Access Compliance Report

Public Rights-of-Way

(Curb Ramps)

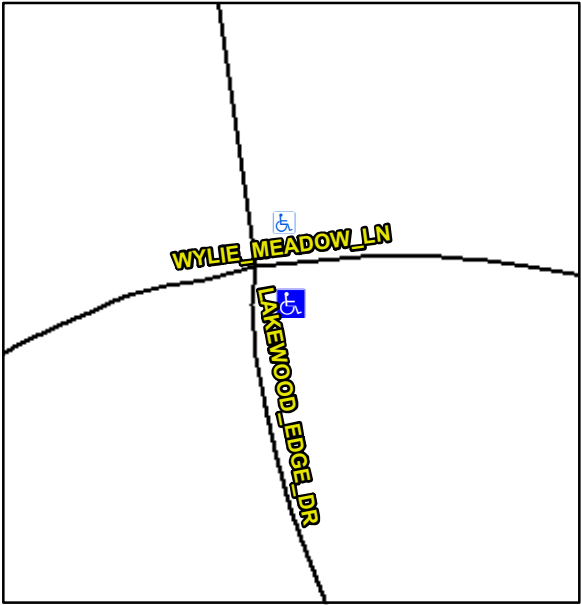
Intersection ID: 4278		Main Street: LAKEWOOD_EDGE_DR	Cross Street: WYLIE_MEADOW_LN	Location:	SE
ADA ID: 37652F1D409F		Ramp Type: Directional1	Initial Pass/Fail: Fail	Overall Compliance: No	Severity Score: 28.75
Codes/Mitigation Info/Possible Solution			Field Measurements/Component Compliance		
		Possible Solutions:	Compliance	Description	Data
		Remove & Replace Entire Ramp.	N/A	Ramp Length (in)	40.0
<p>Surveyor Notes:</p> <p>N/A</p> <p>PROW/ADA:</p> <p>R304.2.2, R304.5.3, R302.7</p>			Yes	Ramp Width (in)	48.0
			No	Ramp Slope (%)	11.5
			No	Ramp XSlope (%)	3.5
			N/A	Flare Type LT	N/A
			N/A	Flare Slope LT (%)	N/A
			N/A	Flare Traversable LT?	N/A
			N/A	Landing Length (in)	0.0
			N/A	Landing Width (in)	0.0
			N/A	Landing Slope (%)	0.0
			N/A	Landing X Slope (%)	0.0
			N/A	Landing Curb? (Y/N)	N/A
			N/A	Shared Landing?	N/A
			N/A	Gutter Ponding?	0.0
			N/A	Gutter Lip Ht (in)	0.0
			N/A	Painted X Walk1?	No
				X Walk 1 Direction	To N

X Walk 1 Width (in)	N/A
				X Walk 1 Slope (%)	4.0
				X Walk 1 X Slope (%)	2.6
			N/A	Ramp inside XWalk1?	N/A
			N/A	Any Obstructions?	N/A
				Obstruction Type	No
			N/A	Surface Condition? (G/P)	Poor
			N/A	Curb Slope (%)	N/A
<p>Street 1 Name</p> <p>Stop Condition-Street 1</p> <p>Street 2 Name</p> <p>Stop Condition-Street 2</p>		<p>WYLIE MEADOWS LN</p> <p>None</p> <p>N/A</p> <p>N/A</p>	<p>Total Cost: \$ 1600.00</p>
